RE: Proposed Interior and Exterior Alteration Remodel Design for:  
2 Osceola Ave Dobbs Ferry, NY 10522; Our Project No.: 21.1209

Please find attached our response below to the Memo Comments received at the last Pre-Submission Conference for PB/AHRB on January 5 2023:

**AI Engineers Comments 12.28.2022**

**Nelson Pope Voorhis Comments 12.28.2022:**

4 WETLANDS

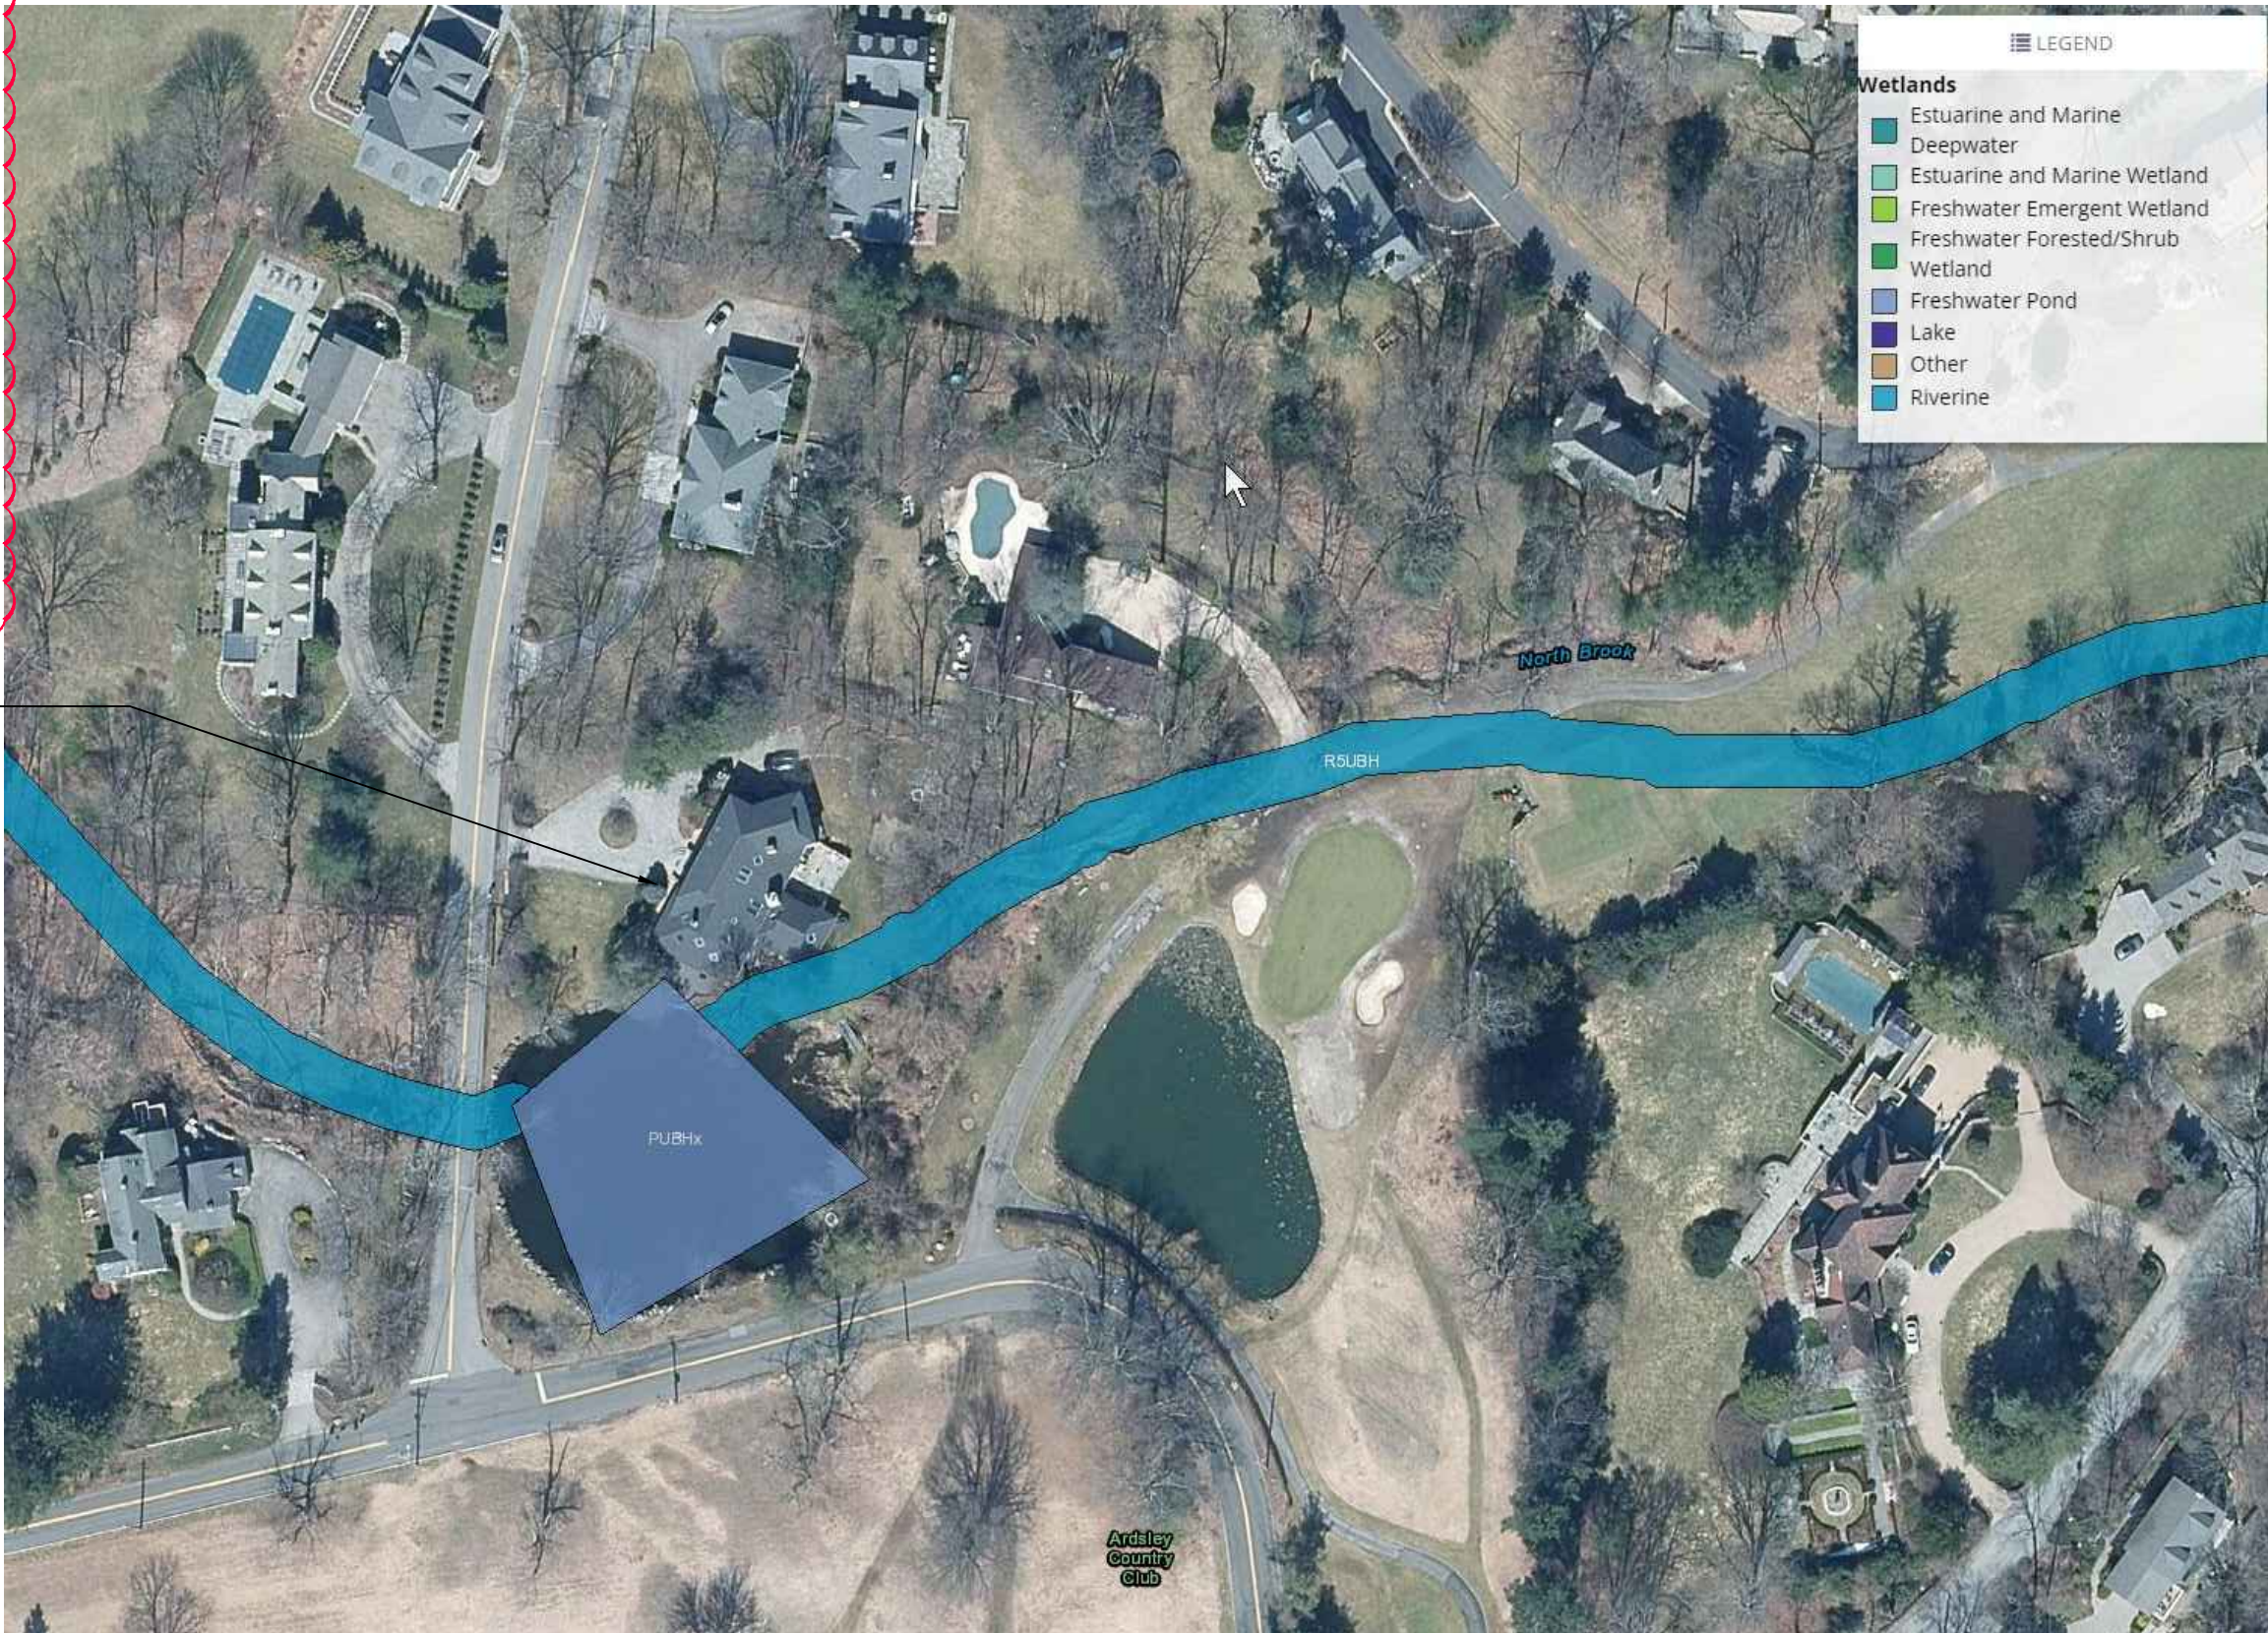
7. **Wetlands.** On sheet T-I, the proposed project appears to encroach into the wetlands. Please provide additional information, including the amount of wetland encroachment and proposed mitigation. If no encroachment is proposed, please update the site plan to show no encroachment into the wetland area.

NLF: The future pool has been removed from the application. The proposed exterior wood deck to be replaced is in generally the same footprint, immediately adjacent to the existing pond. No new footings will be placed within the wetland boundary. We have contacted NYS DEC for formal jurisdiction screening regarding waterbody's and streams and are awaiting a determination. Classification of waterbodies and streams have been included on the plans

DRAWINGS TITLE  
SITE DETAILS & SKY EXPOSURE PLANE

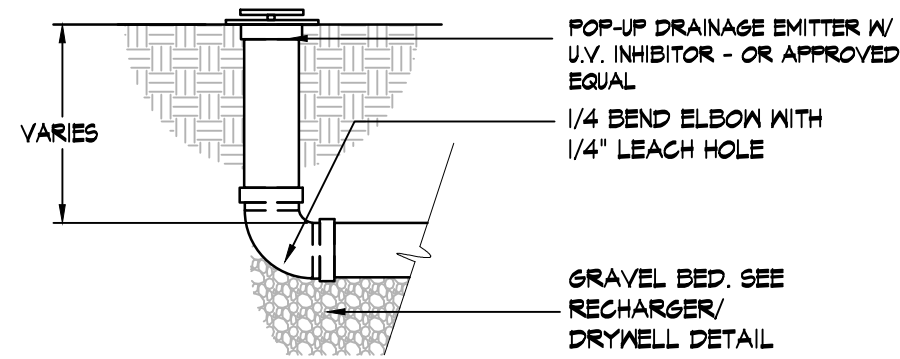
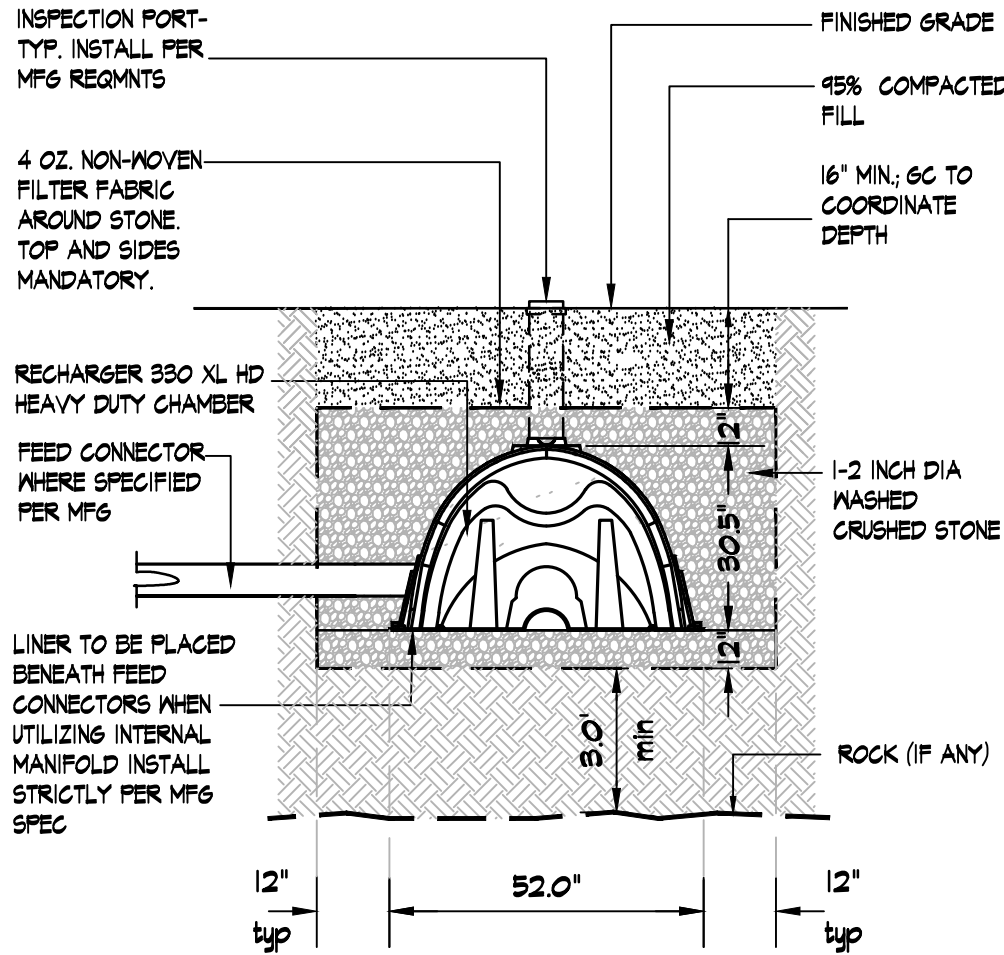
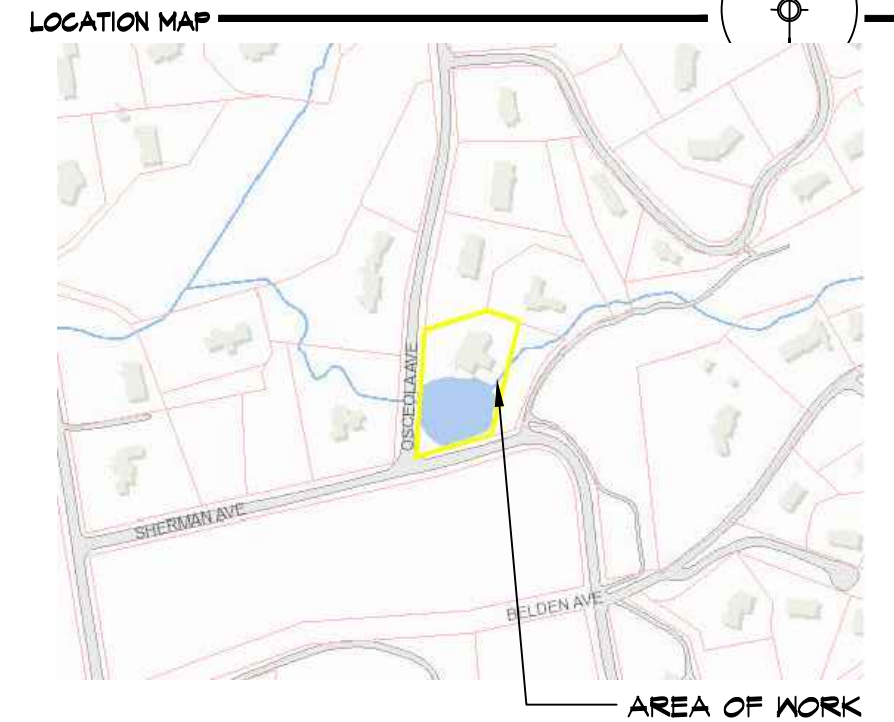
2. The proposed application and increase in impervious area require a stormwater management plan and design calculations in conformance with the New York State Standards and Specifications for Erosions and Sediment Control, NYSDEC's most current version, or its successor. The plan must include all applicable details for sediment and erosion control.

4. **Stormwater Management Plan.** The Applicant has not yet provided a Stormwater Management Plan but has provided details for a silt fence. It is unclear from the submitted plans where this fencing will be located. As per §262-4E of the Village Code, a stormwater management and erosion and sediment control permit must be obtained for any development or land-disturbing activity. Once provided, the Village Engineer will review the plan and comment on this information.

NLF: Sediment Control Details provided on initial submission plans

**NLF:** Silt Fencing indicated on plans as requested.

LANDSCAPE  
PLAN

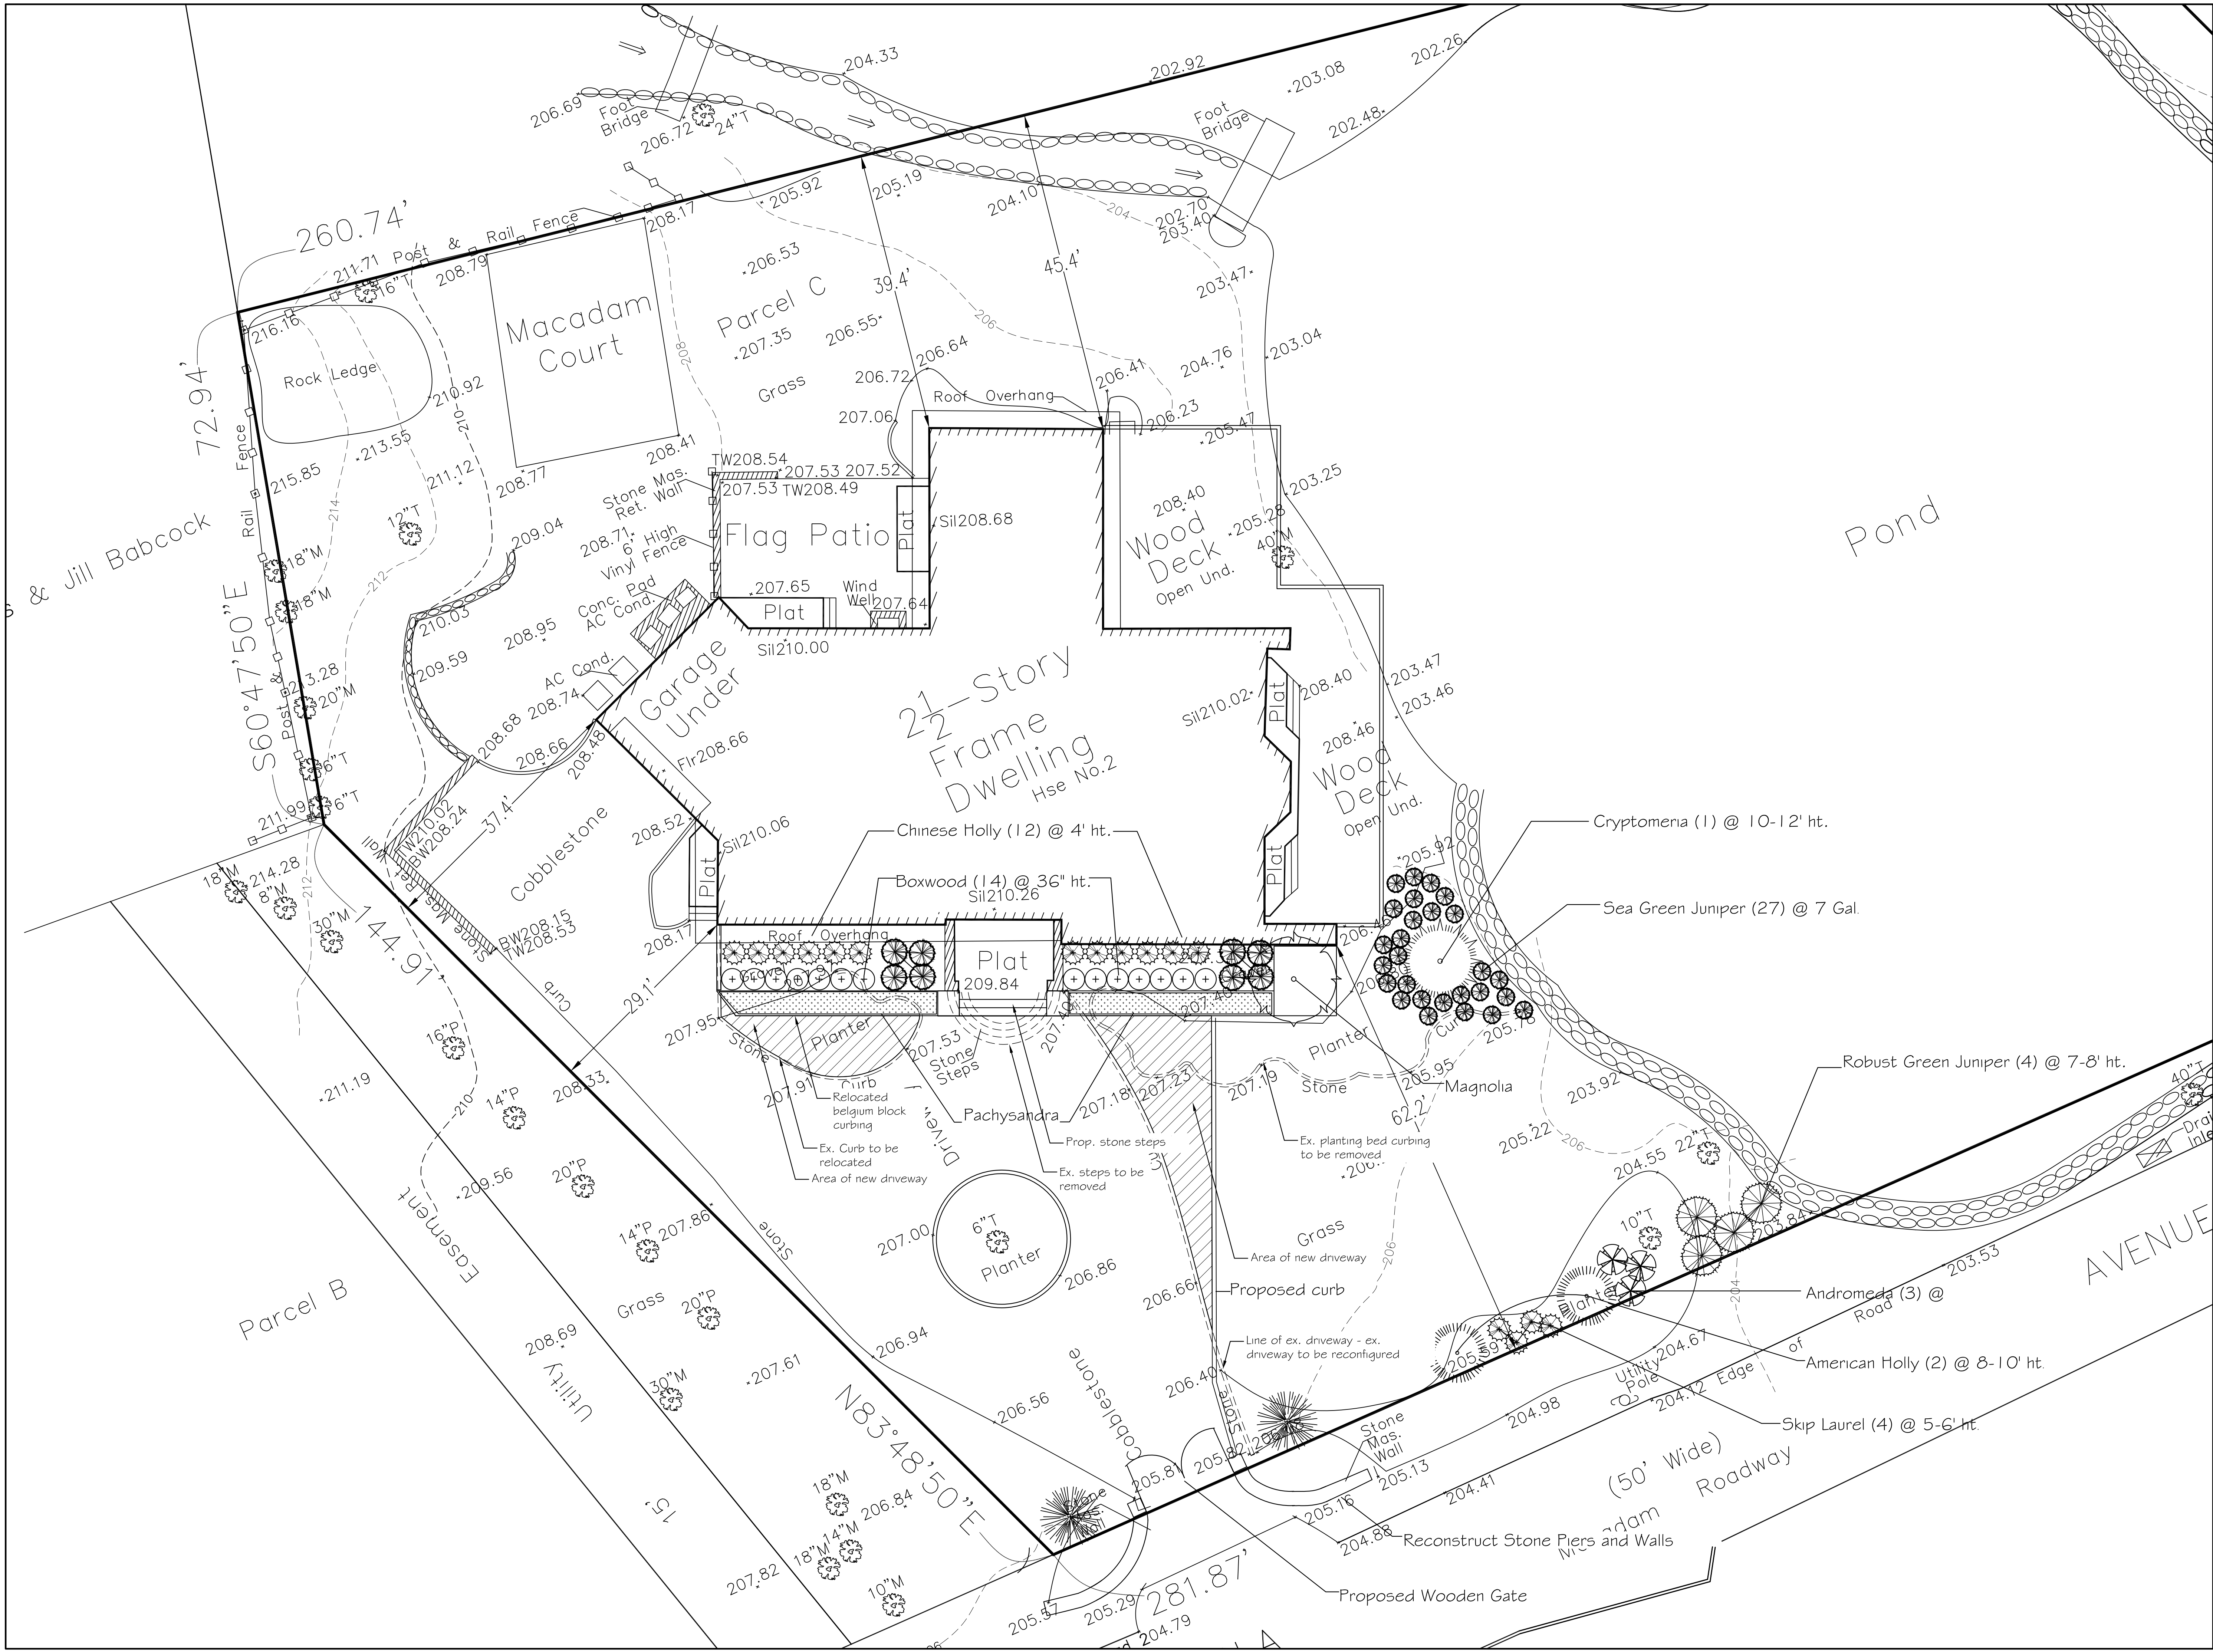
3. **Landscaping.** The Applicant has not provided a landscaping plan per §300-44 of the Zoning chapter, and one will need to be provided.

**NLF:** Landscaping plan provided with original submission and re-attached here
